Legislation Details (With Text)

File #:	17-522	Name:	
Type:	Report	Status:	Passed
File created:	8/1/2017	In control:	City Council
On agenda:	8/28/2017	Final action:	8/28/2017
Title:	Discuss and consider an appeal of the Non-Residential and Multifamily Design Standards and articulation requirements for a proposed diesel mechanic shop addressed at 556 Danken Lane in the "C-3" Commercial District.

BACKGROUND / RATIONALE:**Case No.:** CS-17-014**Council District:** 6**Owner:** Kahlig Enterprises
9207 San Pedro Avenue
San Antonio, TX 78216**Applicant:** Bluebonnet Motors (Wes Studdard)
351 IH 35 S
New Braunfels, TX 78130
(830) 606-8011**Staff Contact:** Matt Greene
(830) 221-4053
mgreene@nbtexas.org***Background:***

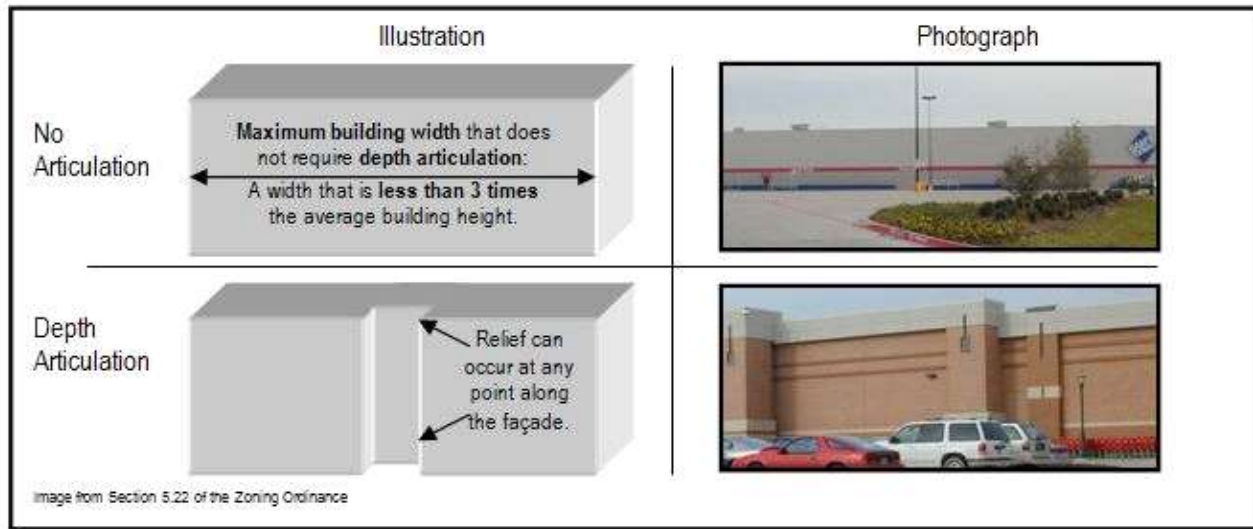
Horizontal Articulation (Attachment 8, Chapter 144, Section 5.22-3(c)(1)):

The horizontal articulation requirements for the proposed building only apply to the building facades facing Danken Lane and Executive Drive. The front facade as proposed would not meet the minimum horizontal articulation requirements. The width of the front façade is 180 feet with an average height of 20 feet. According to the design standards, no portion of the façade shall extend for more than three times the average height (60 feet) without depth articulation. To meet the design standards, there would need to be a minimum of 2 horizontal offsets (relief) at least 3 feet deep (15% of the average building height), extending a width of at least 18 feet (10% of the width of the building façade), positioned on the façade so that no portion of the façade would extend for more than 60 feet without an offset. The required offsets could be an inset or a protrusion as depicted in the following illustration:

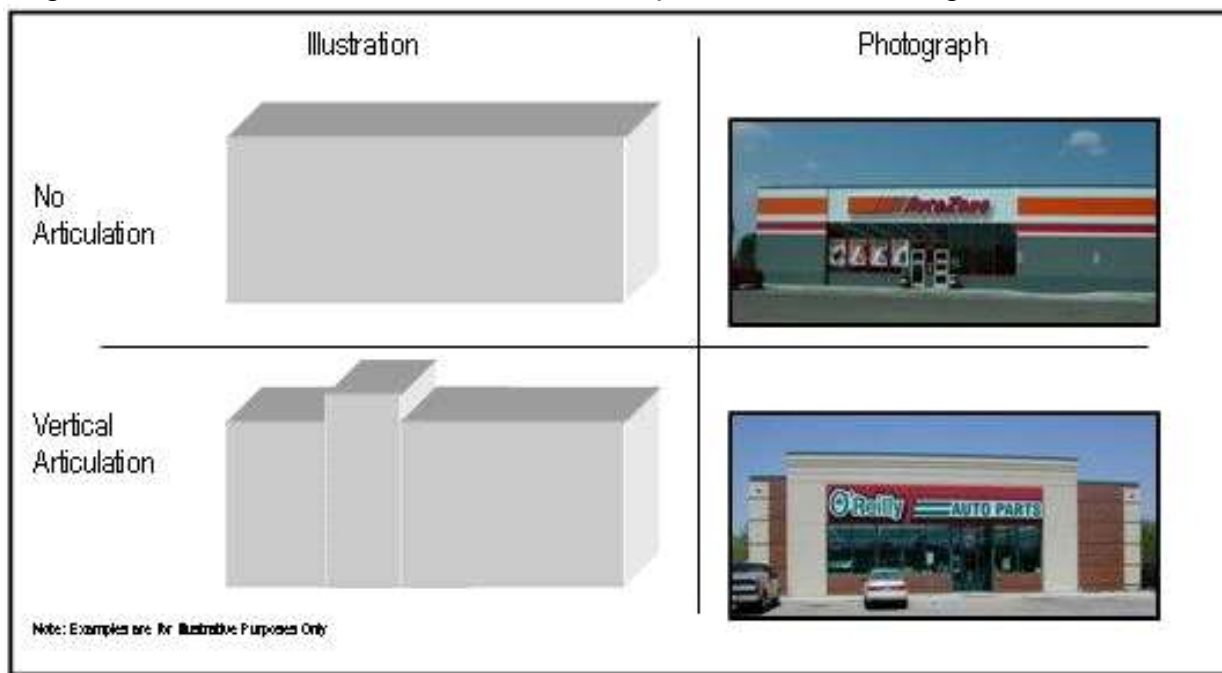
Vertical Articulation (Attachment 8, Chapter 144 Section 5.22-3(c)(2)):

The Vertical articulation requirements for the proposed building also only apply to the building facades facing Danken Lane and Executive Drive. The front facade as proposed would not meet the minimum vertical articulation requirements. The width of the front façade is 180 feet with an average height of 20 feet. According to the design standards, no portion of the façade shall extend for more than three times the average height (60 feet) without a change in façade elevation. To meet the design standards, there would need to be a minimum of 2 vertical offsets (relief) with a change in elevation height of at least 3 feet (15% of the average building height), extending a width of at least 18 feet (10% of the width of the building façade), positioned on the façade so that no portion of the façade would extend for more than 60 feet without an offset. The offsets can be of varying heights as long as the minimal standard is satisfied as depicted in the following illustration:
